UNITED STATES PATENT AND TRADEMARK OFFICE

APPLICATION NO.	FILING DATE	FIRST NAMED INVENTOR	ATTORNEY DOCKET NO.	CONFIRMATION NO.
09/473,315	12/28/1999	LARRY EUGENE MOSLEY	884.209US1	9830

**Office Action Summary**

**DETAILED ACTION**

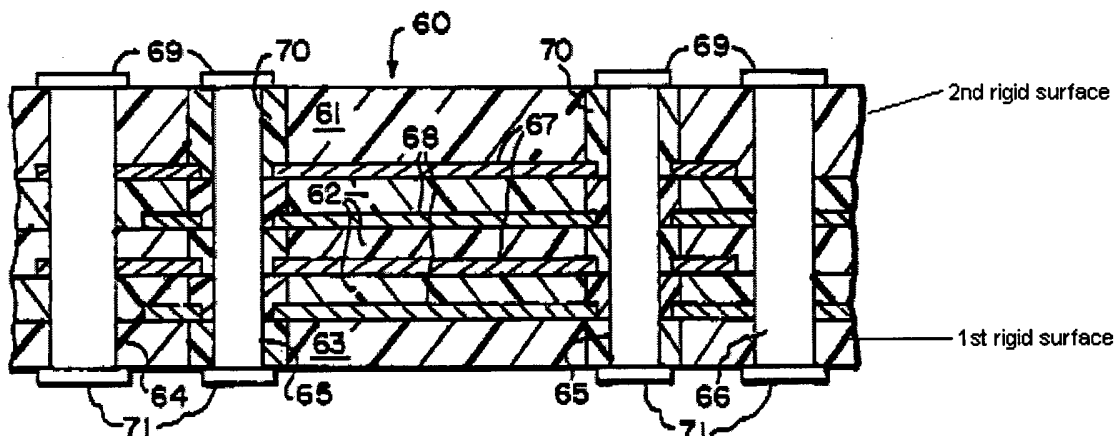
3. Claims 1, 5 are rejected under 35 U.S.C. 102(e) as being anticipated by Naito et al. (US 6,034,864).

Naito et al. disclose in fig. 2A, a capacitor comprising at least four conductive layers (33-34) embedded in a dielectric; and a plurality of vias (40-41) coupling the at least four conductive layers to a plurality of connection sites (38-39).

Regarding claim 5, the vias are plated through-holes.

**FIG. 3B**

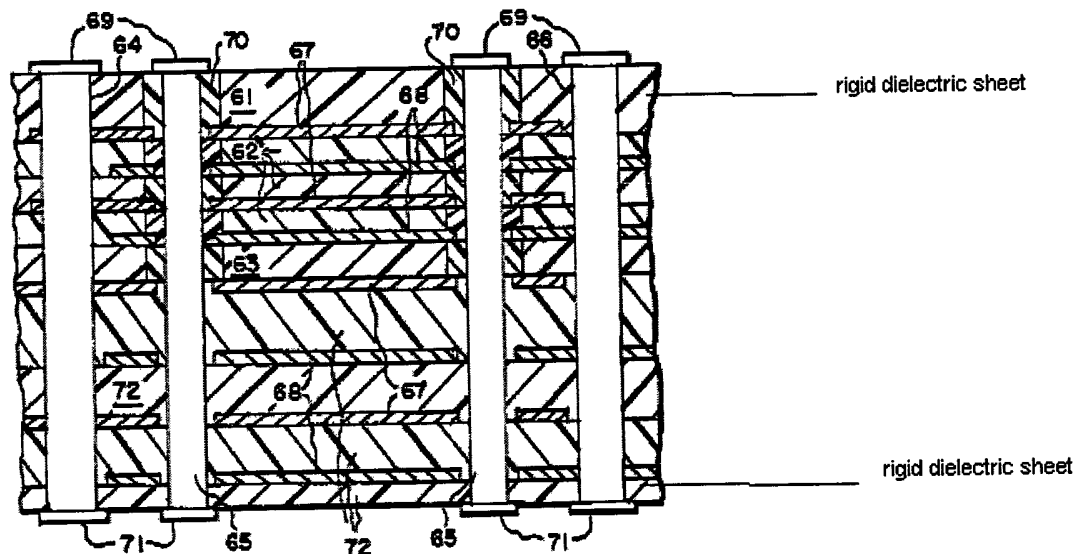
Farooq et al. disclose in fig. 3C, a capacitor comprising: at least four conductive layers (67, 68) embedded in a dielectric; and a plurality of vias (64, 66) coupling the at least four conductive layers to a plurality of connection sites (69).

Regarding claim 9, Farooq et al. disclose in fig. 3 A, a multilayer capacitor having a pair of outer surfaces (see below), and a number of pads (69) located on two of the number of outer surfaces; wherein two of the number of pads are capable of being coupled to a substrate using a solder bump. Although Farooq et al. do not expressly state that the outer surfaces are "substantially rigid", it is an inherent feature of the capacitor of Farooq et al. (see method of forming the capacitor – a fired ceramic green sheet produces a "substantially" rigid surface).

Regarding claim 10, the multilayer capacitor includes a number of parallel conductive layers and the number of pads are coupled to the number of parallel conductive layers through vias.

Regarding claim 6, Farooq et al. disclose (in fig. 3c) a plurality of first conductive layers (67), each of the plurality of first conductive layers formed on a first dielectric sheet (72); a plurality of second conductive layers, each of the plurality of second conductive layers formed on a second dielectric sheet (72), and the plurality of second conductive layers interlaced with the plurality of first conductive layers; a pair of dielectric sheets (see below) having a thickness, for providing a pair of substantially rigid outer surfaces for the plurality of second conductive layers interlaced with the plurality of first conductive layers, each of the pair of substantially rigid outer surfaces having a plurality of connection sites operable for coupling the capacitor to a substrate using a controlled collapse chop connection (C4); and a plurality of vias (64, 66) coupling the plurality of first conductive layers and the plurality of second plurality of second conductive layers to at least two of the plurality of connection sites.

Farooq et al. do not disclose the thickness of the pair of dielectric sheets having a thickness of slightly greater than 7 microns. It would have been an obvious matter of

design choice to form the pair of dielectric sheets having a thickness of slightly greater than 7 microns, since such a modification would have involved a mere change in the size of a component. A change in size is generally recognized as being within the level of ordinary skill in the art. *In re. Rose*, 105 USPQ 237 (CCPA 1955).
